Docket No. 50-277
and 50-278

The Commission has issued Amendment Nos. 63 and 62 to Facility Operating License Nos. DPR-44 and DPR-56 for the Peach Bottom Atomic Power Station Unit Nos. 2 and 3. These amendments revise the Technical Specifications and are in response to your applications dated May 8 and August 2, 1979 as supplemented by information contained in your letter dated October 2, 1979.

The amendment for Peach Bottom Unit 3 (DPR-56) involves:

- (1) use of pre-pressurized fuel for Cycle 4 operation;
- (2) modification of the APRM and RBM setpoint equations;
- (3) deletion of the fuel densification power spiking penalty for 8x8 fuel;
- (4) deletion of the reactor vessel pressure operating limit;
- (5) continued use of the fast scram control rod drive during Cycle 4;
- (6) increase of the standby liquid control system capacity;
- (7) addition of a license condition which governs operation during any coastdown after end-of-cycle;
- (8) revision of the withdrawal schedule for the reactor vessel material surveillance program, and
- (9) administrative changes relating to reporting of primary and secondary leak rate test results, members of the Operation and Safety Review Commit

Figure 3.4.1

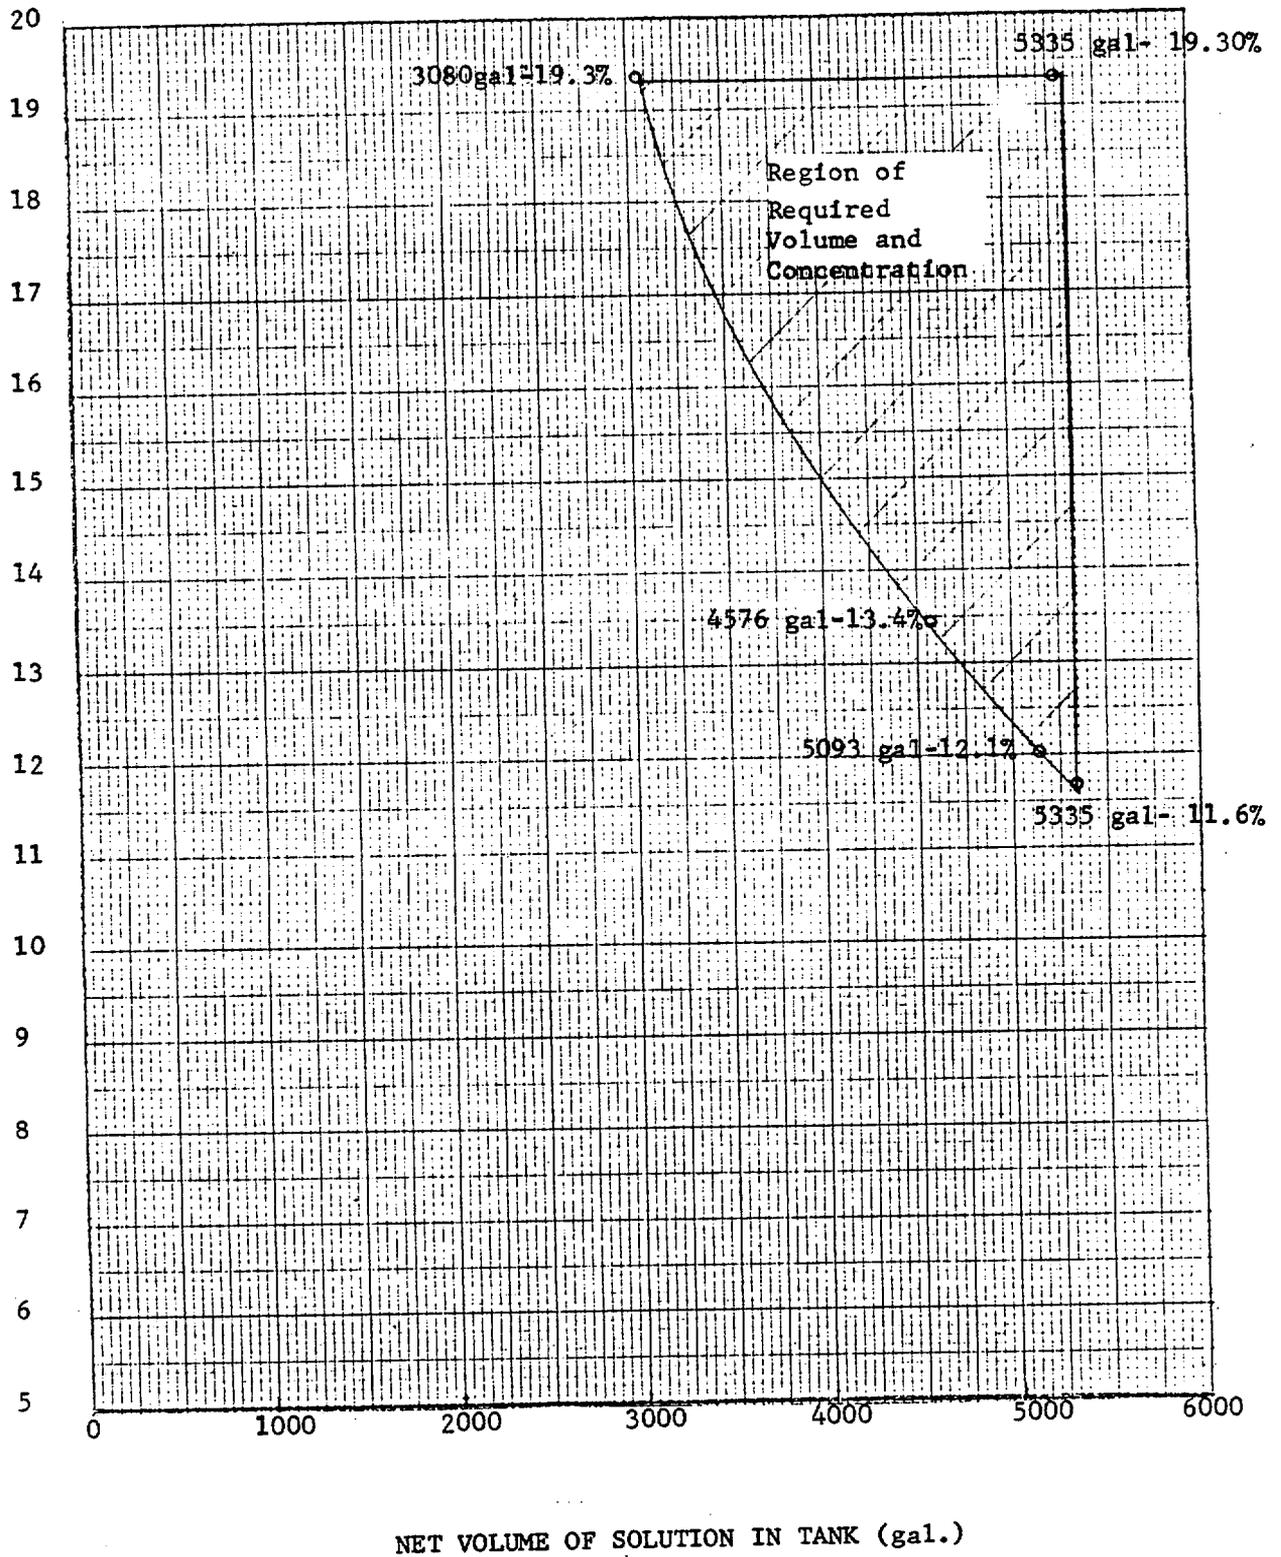
A minimum quantity of 3080 gallons of solution having a 19.3 percent sodium pentaborate concentration, or the equivalent as shown in Figure 3.4.1, is required to meet this shutdown requirement. The minimum required pumping rate of 43 gpm is based on the injection of the maximum volume permitted in Figure 3.4.1 in less than 125 minutes.

Figure 3.5.1.H Maximum Average Planar Linear Heat Generation Rate

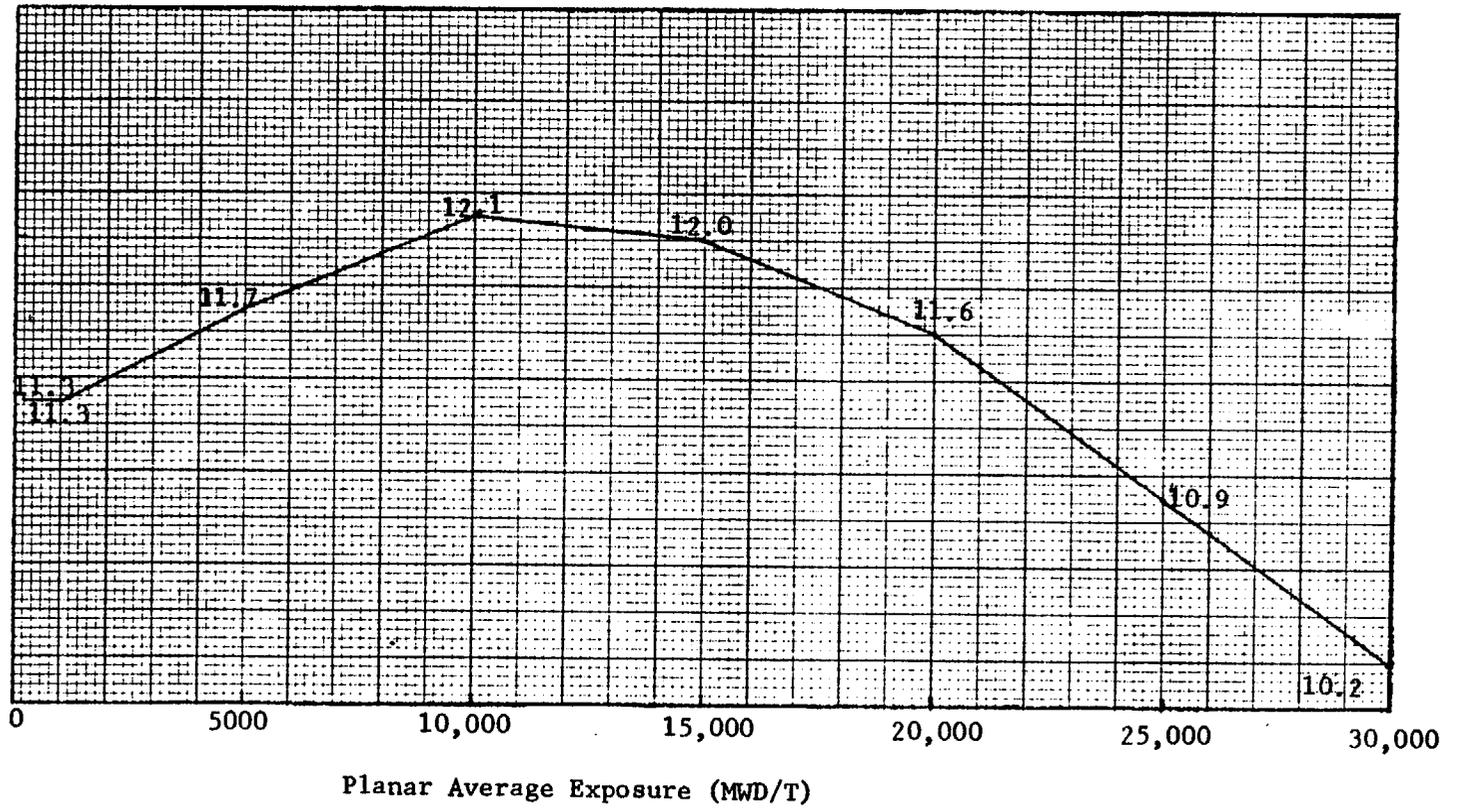
During power operation, the APLHGR for each type of fuel as a function of average planar exposure shall not exceed the limiting value shown in Figure 3.5.1.A, B, C, D, F, G & H as applicable. If at any time during operation it is determined by normal surveillance that the limiting value of APLHGR is being exceeded, action shall be initiated within one (1) hour to restore APLHGR to within prescribed limits. If the APLHGR is not returned to within prescribed limits within five (5) hours reactor power shall be decreased at a rate which would bring the reactor to the cold shutdown condition within 36 hours unless APLHGR is returned to within limits during this period. Surveillance and corresponding action shall continue until reactor operation is within the prescribed limits.

The calculational procedure used to establish the APLHGR shown on Figures 3.5.1.A, B, C, D, F, G, and H is based on a loss-of-coolant accident analysis. The analysis was performed using General Electric (GE) calculational models which are consistent with the requirements of Appendix K to 10 CFR Part 50. A complete discussion of each code employed in the analysis is presented in Reference 4. Input and model changes in the Peach Bottom loss-of-coolant analysis which are different from the previous analyses performed with Reference 4 are described in detail in Reference 8. These changes to the analysis include: (1) consideration of the counter current flow limiting (CCFL) effect, (2) corrected code inputs, and (3) the effect of drilling alternate flow paths in the bundle lower tie plate.
